LR-N04-0175

**RESPONSE TO REQUEST FOR ADDITIONAL INFORMATION  
REGARDING RELAXATION REQUEST S1-RR-I3-B21,  
FIRST REVISED NRC ORDER (EA-03-009) ON REACTOR PRESSURE VESSEL  
HEAD INSPECTIONS  
SALEM GENERATING STATION UNIT NO. 1  
FACILITY OPERATING LICENSE NO. DPR-70  
DOCKET NO. 50-272**

**Response to NRC Request For Additional Information  
Relaxation Request S1-RR-I3-B21  
First Revised NRC Order EA-03-009**

Figure 1

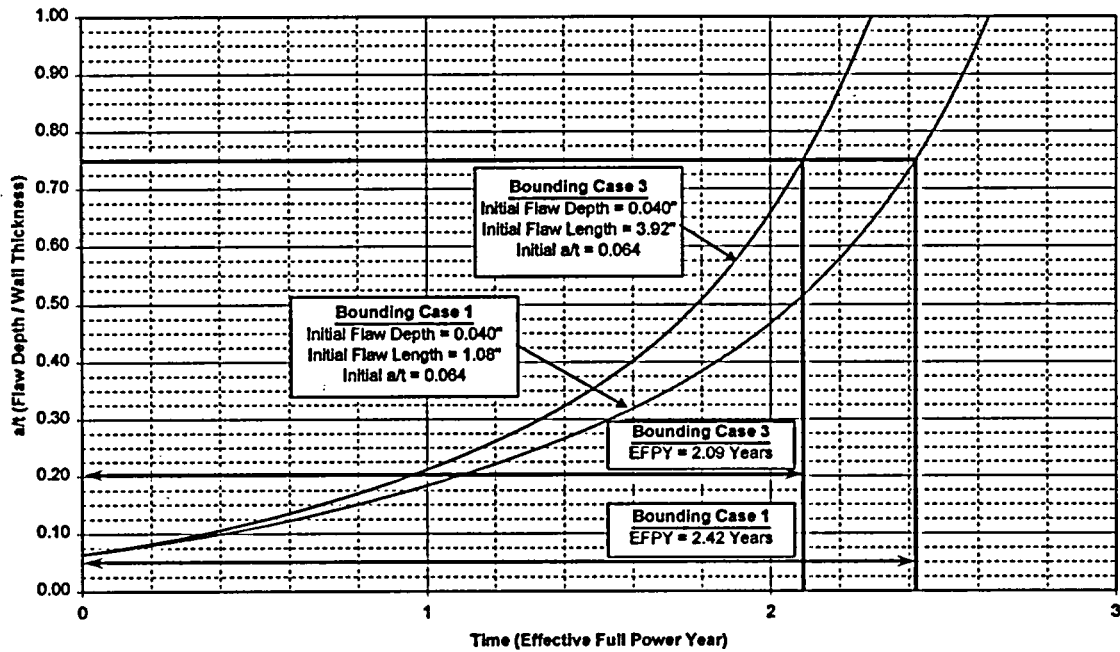
**NRC Question 4:**

As per our phone conversation on April 8, 2004, provide a table (similar to Table 3-1 in RAI response dated March 2, 2004) listing the distance below the toe of the weld that was actually volumetrically examined. Provide a minimum and a maximum. Include examination distance on the uphill and downhill side of each nozzle using UT and ECT (separate columns) examinations for nozzle numbers 74-79 and any other nozzles that did not obtain at least 1.0" below the lowest point at the toe of the J-groove weld (on a horizontal plane perpendicular to the nozzle axis).

The craze cracks found in various penetration nozzles are grouped to obtain the following four bounding cases. Crack growth curves for these bounding cases are generated and shown in Figures 1 and 2. The results of the crack growth calculation in Figures 1 and 2 show that the remaining service life of these craze cracks before repair is necessary is more than one fuel cycle. This is a very conservative evaluation and in general there are no detectable depths for these craze cracks and no crack propagation due to Primary Water Stress Corrosion Cracking (PWSCC) is expected. Therefore, it can be concluded that all the craze cracks found in various penetration nozzles are acceptable.

Bounding Crack Growth Curves for Inside Surface Axial Craze Cracks  
(Downhill Side of the Penetration Near the Attachment Weld)
